**CITY OF SAINT PAUL**  
**HERITAGE PRESERVATION COMMISSION STAFF REPORT**

**FILE NAME:** 172 East Fourth Street  
**DATE OF APPLICATION:** January 22, 2015  
**APPLICANT:** Twin Cities Public Television, JoAnn Hawkins  
**OWNER:** HRA, 25 Fourth Street West  
**DATE OF PUBLIC HEARING:** March 26, 2014  
**HPC SITE/DISTRICT:** Lowertown Heritage Preservation District  
**CATEGORY:** New Construction  
**CLASSIFICATION:** Building Permit, Sign Permit  
**STAFF INVESTIGATION AND REPORT:** Amy Spong  
**DATE:** March 20, 2015

### Skyway Atrium - Exterior Design and Enhancements

Sheet Number  
**A300**

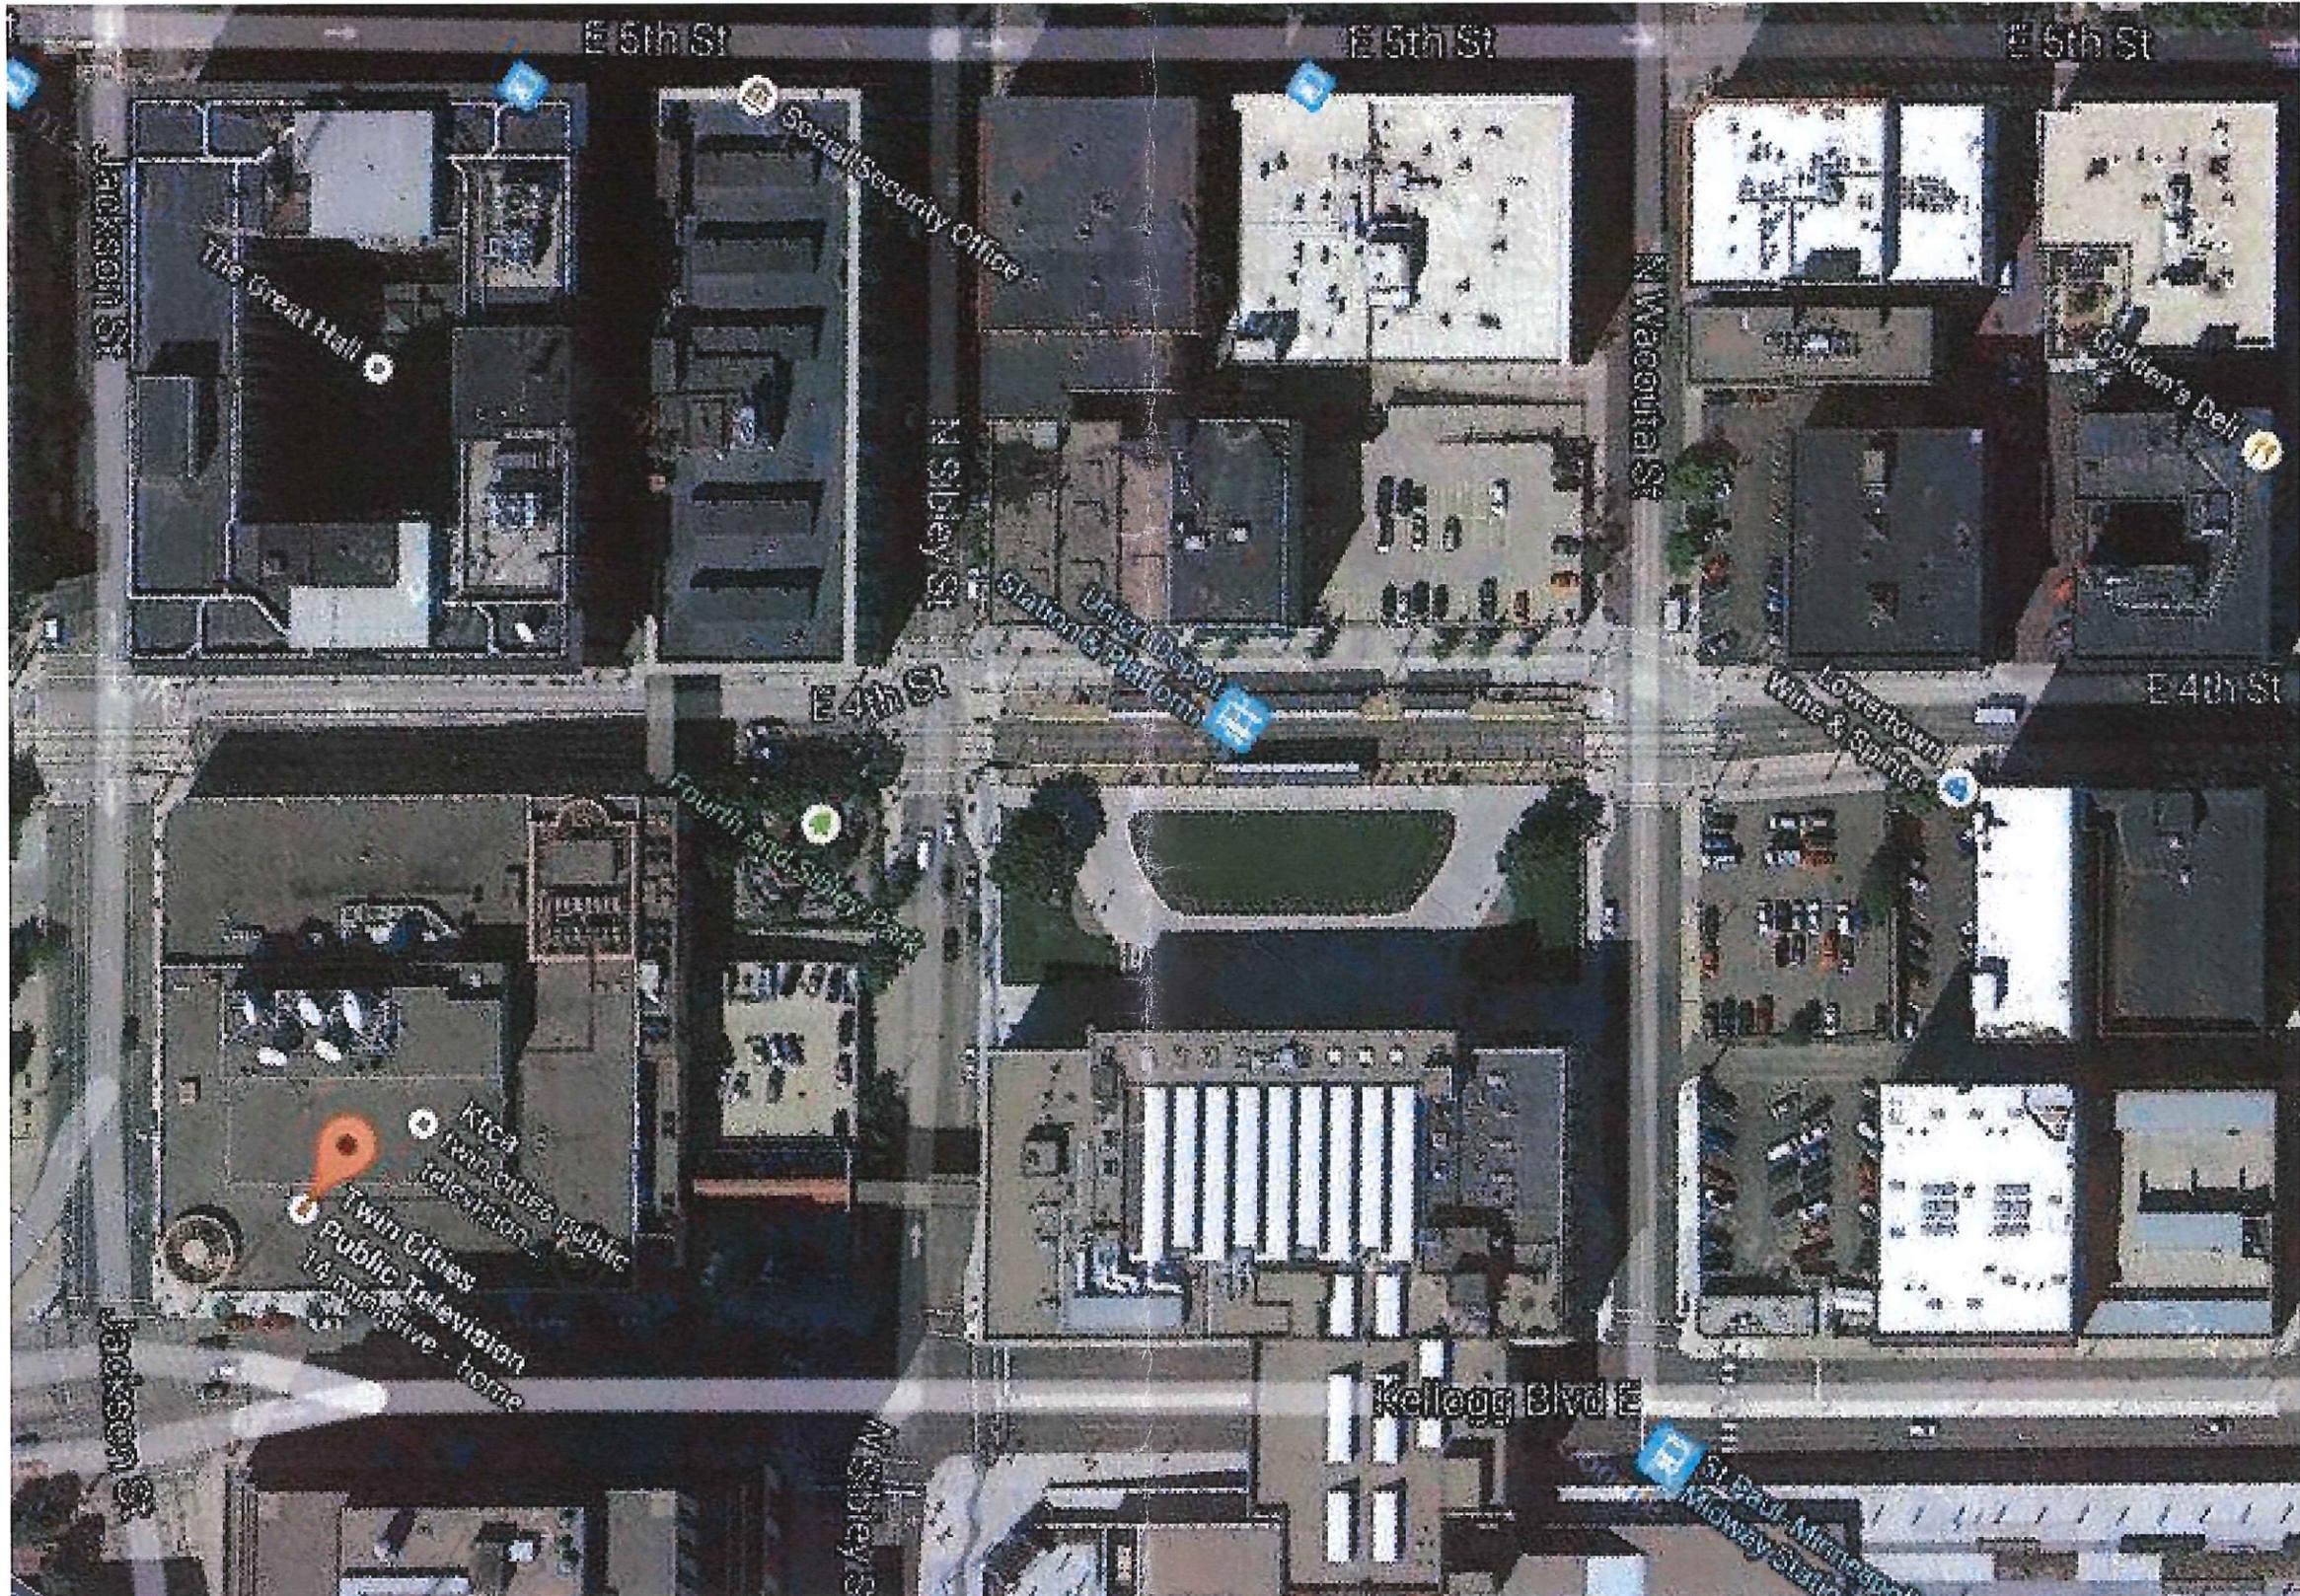
The off-white is not compatible with the masonry character of the district and should be a darker color with a tone that is found in the variety of red, brown and yellowish tones of adjacent brick. The projection screen which requires the off-white color should be a temporary element in canvas that gets installed for events or if the painting of off-white is approved it should be framed with the darker paint color. This would recall a frame around a more traditional painted wall sign. The wall should be a more permanent and compatible feature within the Historic District, not making it further incompatible.

7. The guidelines state “*Double-hung windows are traditional in the district, and are preferred for new construction. Window mullions should emphasize their vertical direction.*” The applicant proposes to improve the appearance of the “substandard” elevation by expanding the existing opening and installing a new window on the skyway level. While not double-hungs as the guidelines recommend, they have a vertical orientation and relate to existing windows on the 4th Street elevation. The new storefront opening and window faces into the children’s park and does improve the pedestrian connection but not at a primary street/sidewalk elevation. Detailed window profiles, color and dimensions were not provided.

3. East wall: The final brown wall color shall be compatible with the existing brick on the building, a darker/natural tone, but shall also complement the "limestone" base around the parking garage. Final color options shall be provided and three HPC members will be called to consult and approve the final color.

4. East wall: The approved dark color shall be used for the whole east wall elevation except for the area where the mural is and the 32' x 56' area that will be used as a "video wall." The current salmon color will not be reintroduced as the background for the mural as well. In consultation with the artist, a different and neutral color will be used as the mural background. The new dark color will also be used at the mechanical structure and wall that faces the children's park.

5. All new window and door glass shall be two-way and clear. No reflective or tinted glass is approved. Detailed plans and specifications, including window profiles, shall be submitted to staff for final review and approval.

Existing Conditions (2014)

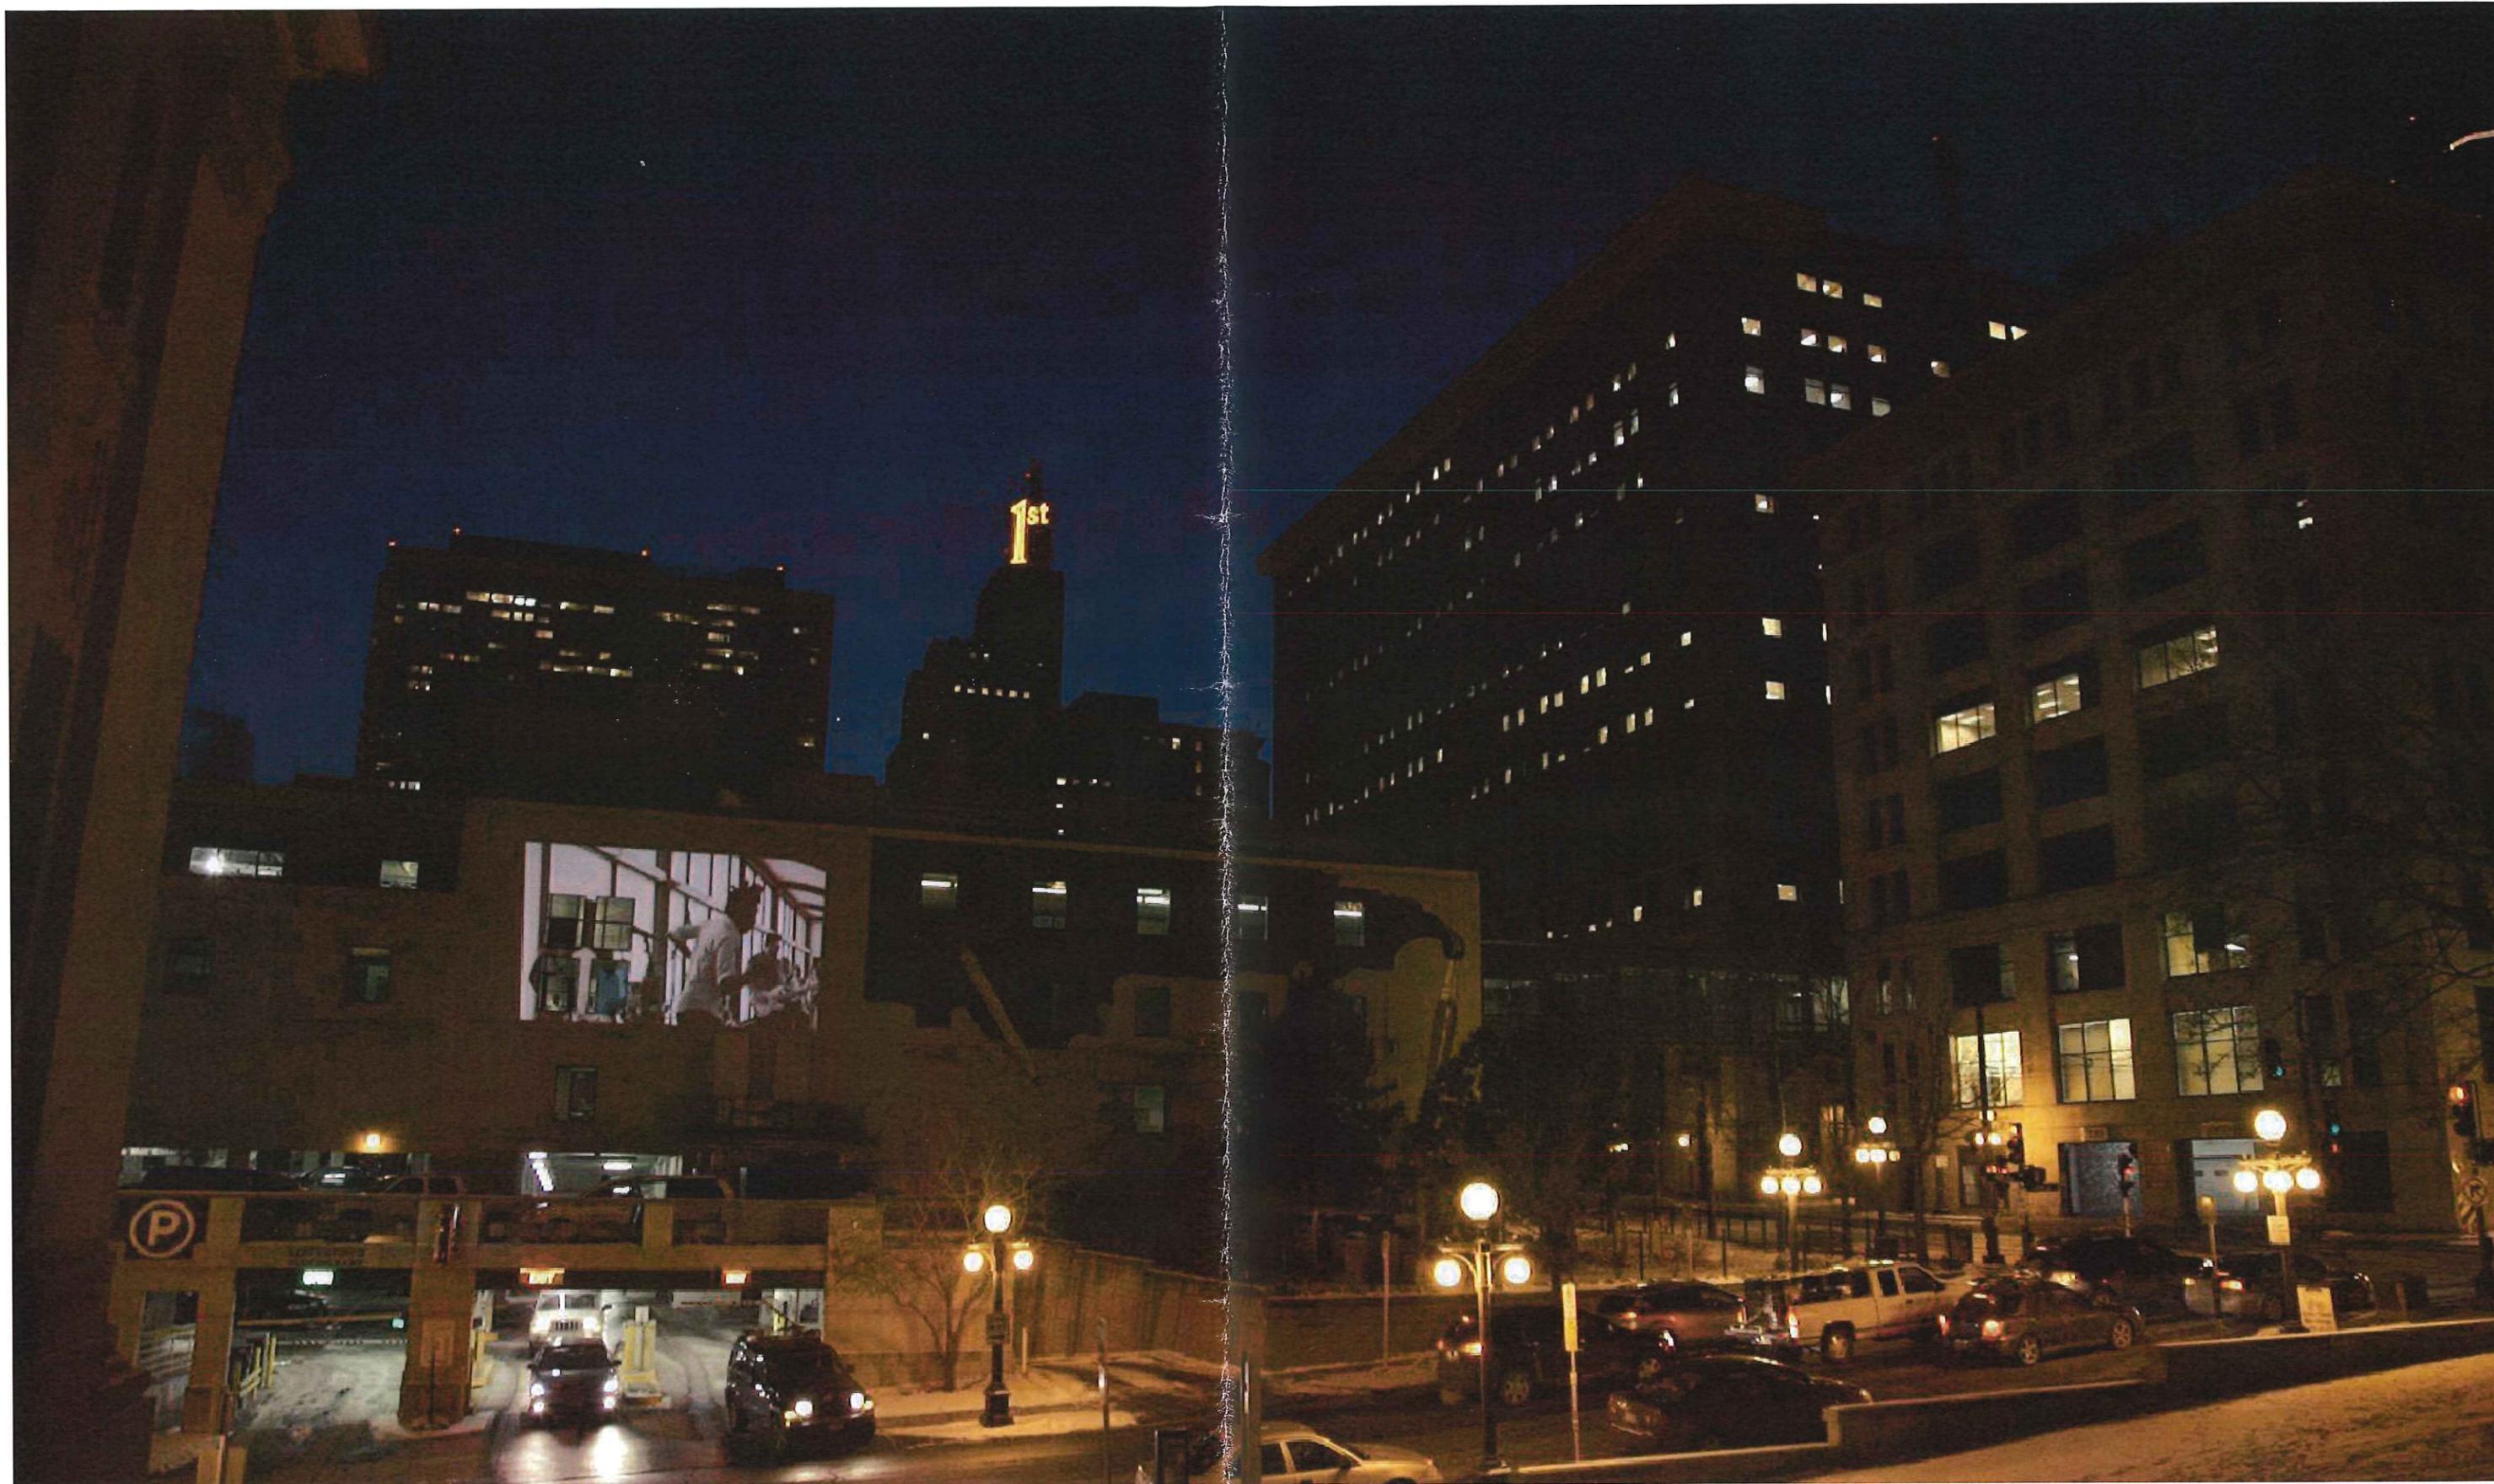
3. The application states the eastern wall is of a substandard material with no relationship to the neighborhood or St. Paul Lowertown. The application does not make clear if the substandard nature is both visual and physical (structural) or just visually substandard. The proposal is not to replace the material but repaint it in an off-white color outside of the mural areas and a brown color on the southern portion of the wall. The proposal to repaint the temporary materials and then consider it permanent does not comply with the former HPC findings and decision nor with the guidelines (unchanged when first applied in 1987 and 1989) that state “Walls of buildings in the district are generally of brick, or occasionally of stone. All non-masonry surfaces, if painted, should be of colors compatible with the masonry character of the district.”

The location of the upper eastern wall does not comply with the guideline that states “*There should be no sign above the cornice line or uppermost portion of a facade wall.*” There is no historic fabric or architectural detailing being concealed. Given this is a highly visible secondary elevation, a painted sign that complements the character of the early painted signs is acceptable in this upper wall location. The goose-neck lights above the sign, however, are not appropriate as a way to light a wall sign at the upper façade wall. If lighting is desired, then a light source could be added at the parking deck (similar to the pole mounted fixture to project video on the other portion of the wall).

The sign above the entrance on 4<sup>th</sup> Street does cover the transom windows but if there is a “*space separating them from the building*” this may be acceptable. The sign is of a raw metal which is not appropriate and the solid nature and thickness of the sign blocks and conceals the transom windows. The structure does have some space from the entry system but not from the “building” edge. The background element should have a painted finish and be more transparent.

1. East wall sign: Detailed plans and specifications shall be provided to HPC staff for final review and approval. The sign shall be painted with an appropriate paint and no vinyl or film-type products are allowed. The sign shall not be lit with the proposed lights above but rather a fixture added at the parking deck or skyway shall be done if exterior lighting is desired.

2. North entry sign: The solid panel shall be revised to a thin and more visually open material to allow for the storefront transom to be visible. There shall be no unfinished or raw metal but only painted metal is allowed. Final detailed plans and specifications shall be submitted to staff for final review and approval.
